Access Compliance Report

Public Rights-of-Way

(Curb Ramps)

Intersection ID: 44929	Main Street: TWIN_BROOK_DR	Cross Street: TWIN_BROOK_DR	Location: S
ADA ID: 552B44ACD928	Ramp Type: Perp	Initial Pass/Fail: Pass	Overall Compliance: No
Severity Score: 0			
Codes/Mitigation Info/Possible Solution		Field Measurements/Component Compliance

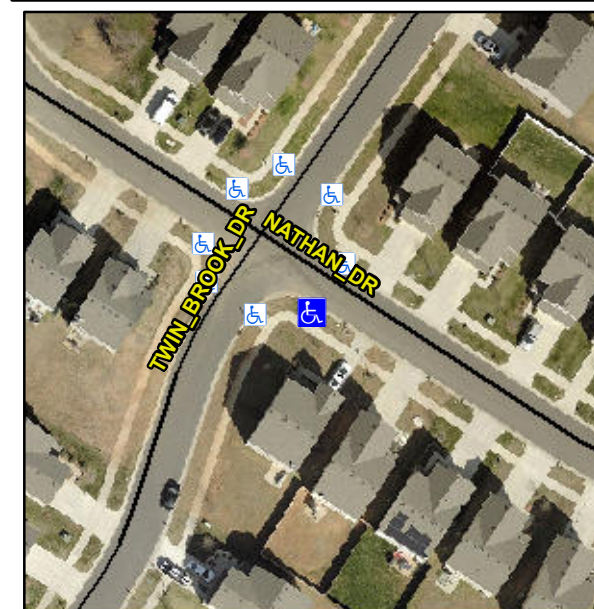
Remove & Replace Detectable Warning System.

R305.2
